SUB-2017 -74 and LUC-2017-407- 34 GORMAN STREET, DUNEDIN - Request for further information

Re: 34 Gorman Street – s92 responses - Landscape

32 Gorman Street, Macandrew Bay - S92 Queries - Landscape

34 GORMAN STREET
PROPOSED 3 LOT SUBDIVISION
MACANDREW BAY
LANDSCAPE REPORT

Residence @ 34 Gorman Street - 2017

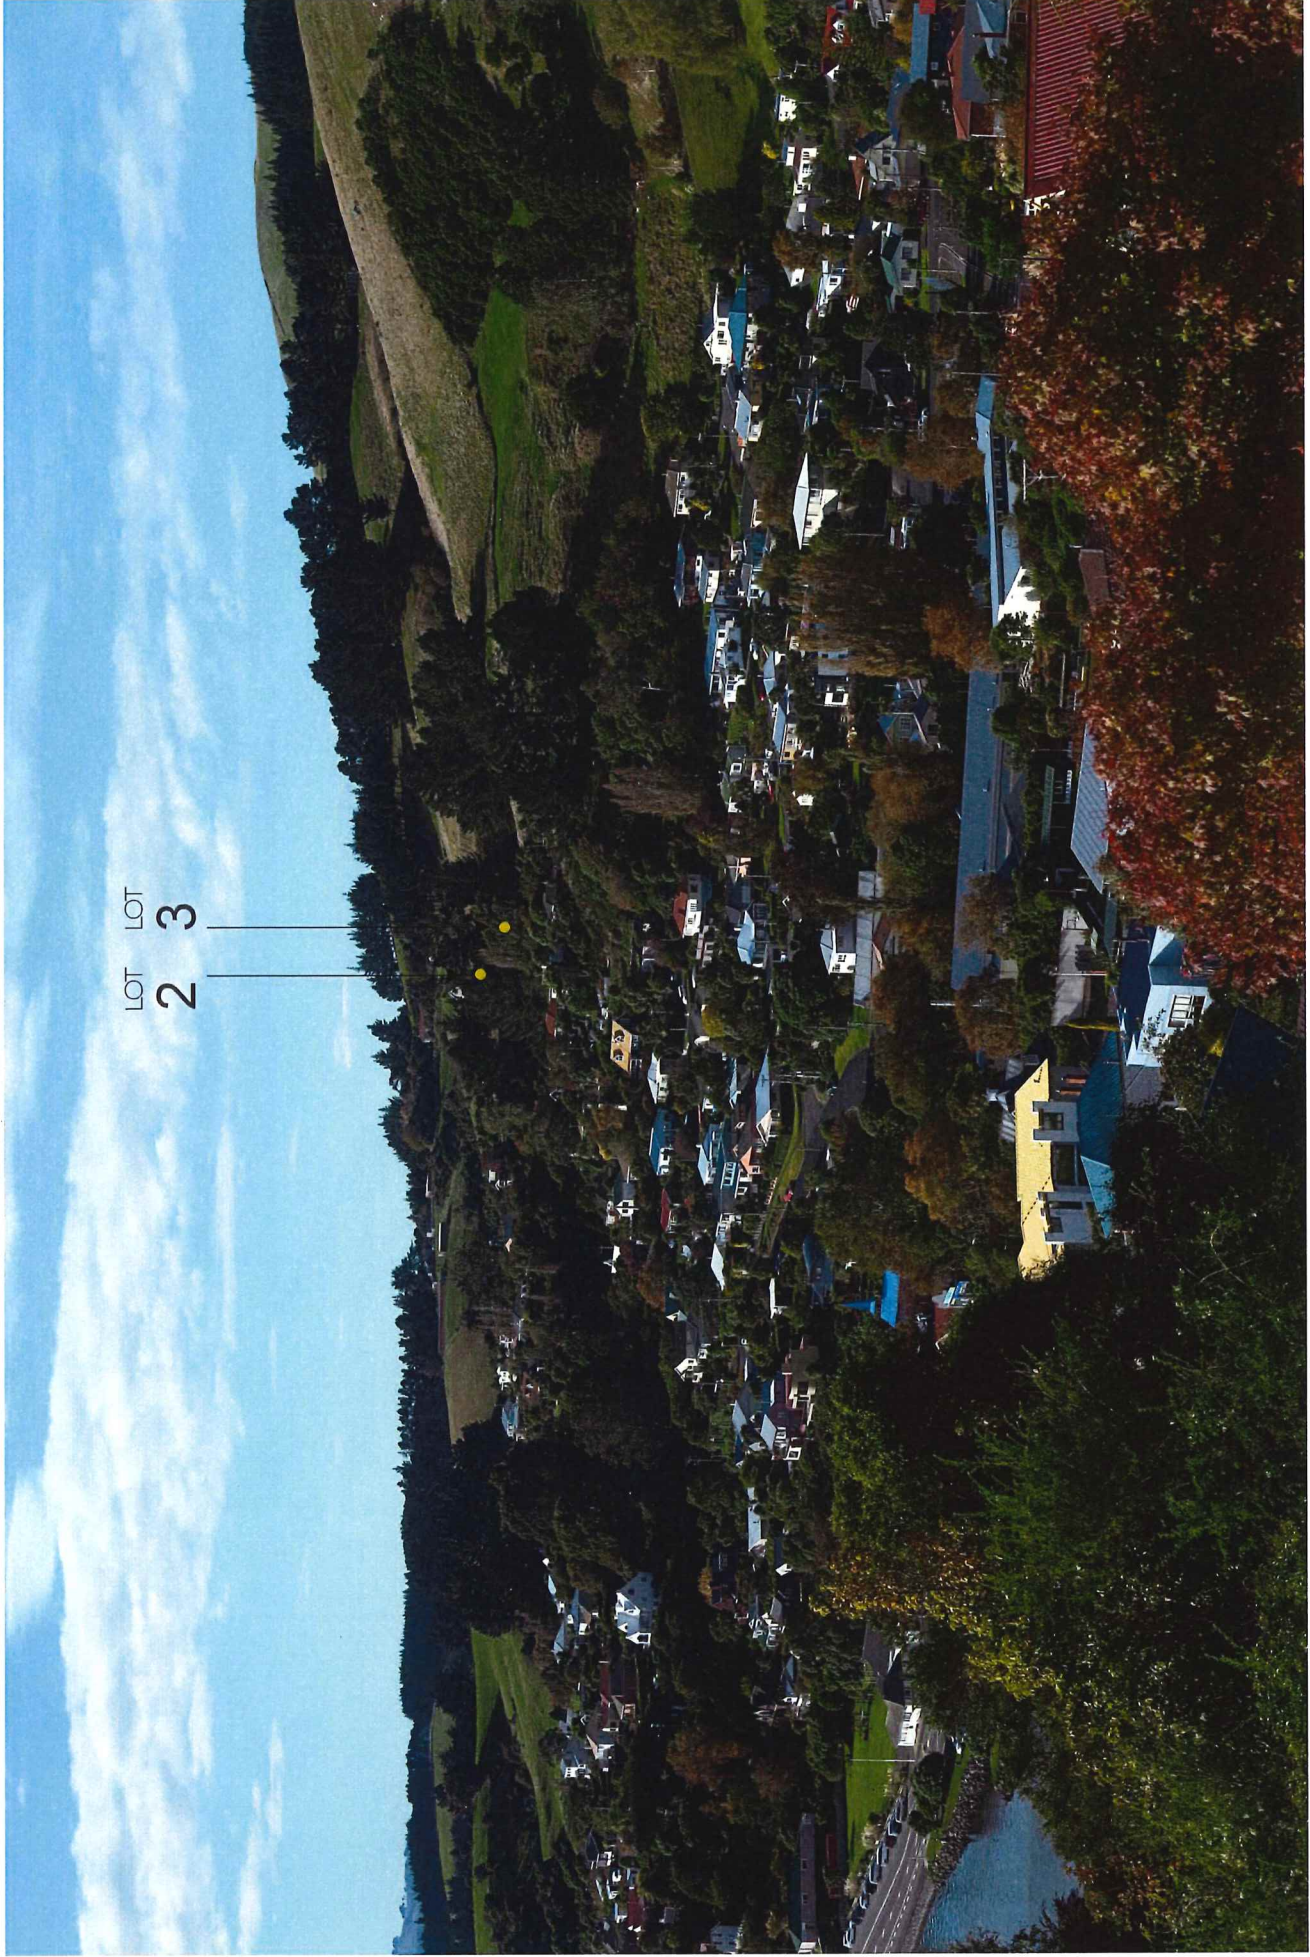
- *Please provide further information on how you wish to proceed with this planting and existing consent?*

Pumped water would be required to supply weekly watering of all planting throughout the first, and possibly second, summer season and was beyond resources for the applicant as they established their house. Mitigation planting has been established around the residence and is still being added to and maintained (Fig.4).

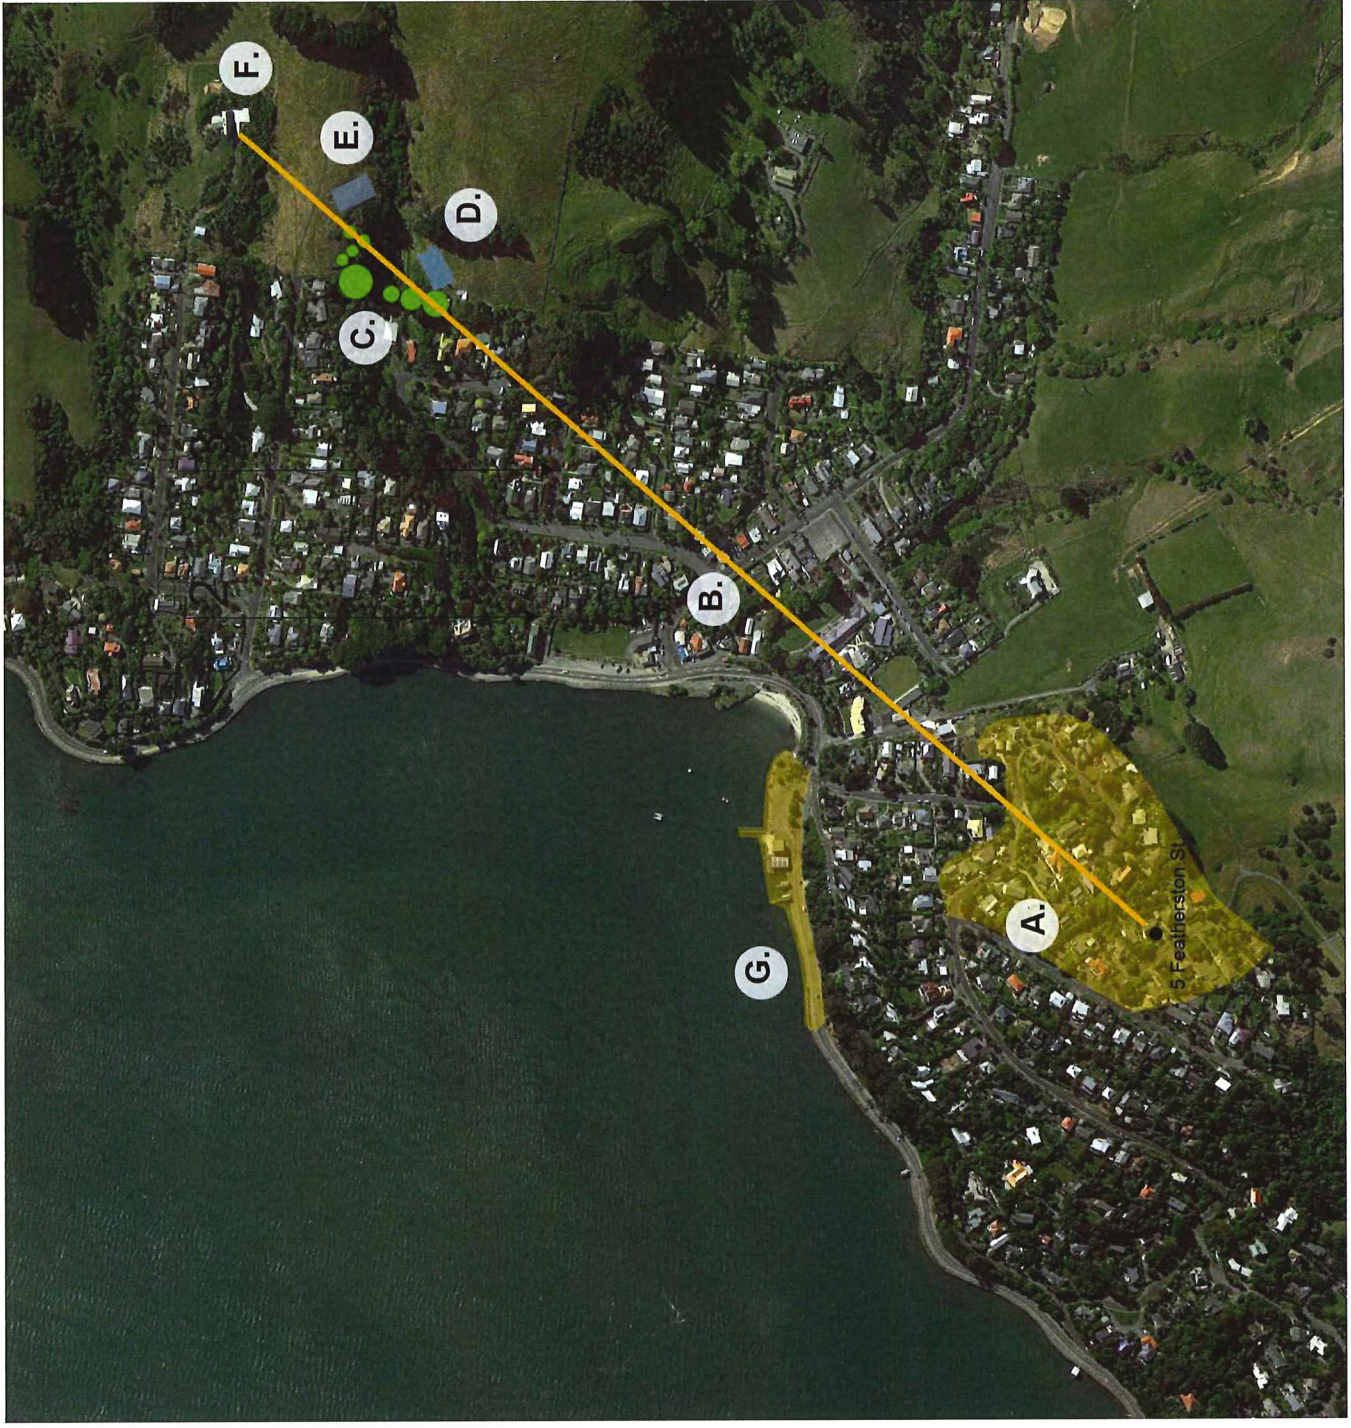
- *Show the effects of removing the large pine trees and effects of the proposed planting? Have the visual effects been taken into account?*

- *Show the vehicle access, earthworks and bulk of proposed buildings*

The yellow dots represent building platforms that are located within the lots.

The effect of removing the pine trees was assessed during concept development. The objective of removing them is to increase sun and wind flow within the gully area at the top of Wharfdale Street and also to avoid the trees reaching the size of the tree adjacent to 40 Porterfield Street.

The access ways are set out on figure 13. The bulk of the proposed buildings cannot be assumed apart from a maximum height limit of 7m, including roof until building consent. This height is 3m lower than standard rural residential rules and, due to the generally screened location of the proposed lots and the distance of most potential viewers, is considered to adequate provision for assessment of potential effects at outline subdivision consent stage.
